Appl. No.: 10/672,655  
Amdt. dated June 22, 2005  
Reply to Office action of March 21, 2005

**Amendments to the Drawings:**

**REMARKS**

FIG. 2

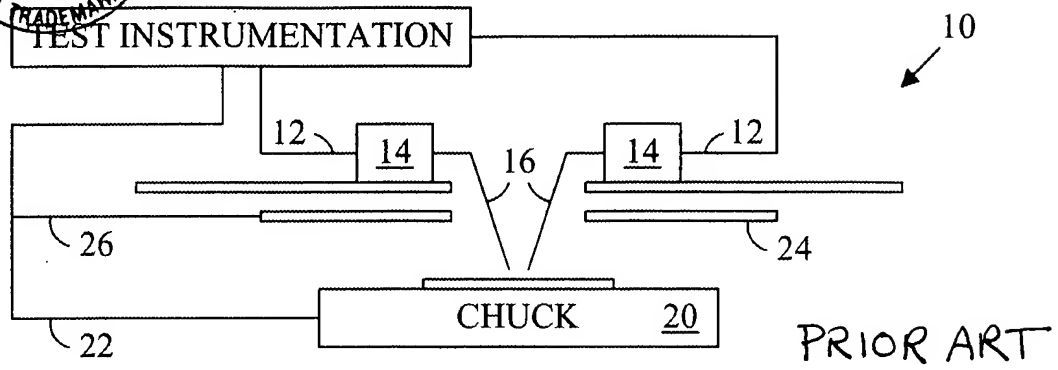
The Examiner objected to the drawings, requiring that FIG. 2 be labeled as prior art because it illustrates only that which is old. Enclosed is a corrected sheet labeling FIG. 2 as prior art.

The Examiner's rejection is premised on the incorrect assumption that FIG. 2 depicts something other than that shown in FIG. 1; it does not. As stated in the specification, FIG. 2 is nothing more than a schematic illustration of the probe station of FIG. 1 showing a large inductance loop identified by the present inventors as problematical. See Specification at p. 4, lines 1-5. Thus, although the schematic diagram of FIG. 2 shows a single block for the three-stage chuck 20, it is incorrect to assume that FIG. 2 shows the transmission line 22 electrically connected to the upper surface of the chuck.

In this instance, the specification describes FIG. 2 merely as a "schematic illustration." Viewed alone, it shows no details of the chuck 20. Thus, even though the schematic drawing shows that the transmission lines 22 and 26 electrically interconnect some part of the prior art chuck to the suspended guard, one would not conclude specifically that the *surface* of the chuck is electrically connected to the suspended guard. In fact, the specification and FIG. 1, which shows a more detailed version of the chuck of FIG. 2, makes clear that the upper surface of the prior art chuck is electrically isolated from the suspended guard. Therefore, not only has the Examiner failed to show that applicant's admitted prior art either expressly or inherently discloses the limitation of "wherein said *surface* is electrically interconnected to said second conductive member", but applicant's admitted prior art actually shows the opposite; that the

The attached sheet of drawings includes changes to FIG. 2. This sheet, which includes FIGS. 2, 4, and 6, replaces the original sheet including FIGS. 2, 4, and 6. FIG. 2 is now labeled as Prior Art.

Attached is a corrected sheet depicting FIG. 2 as prior art.
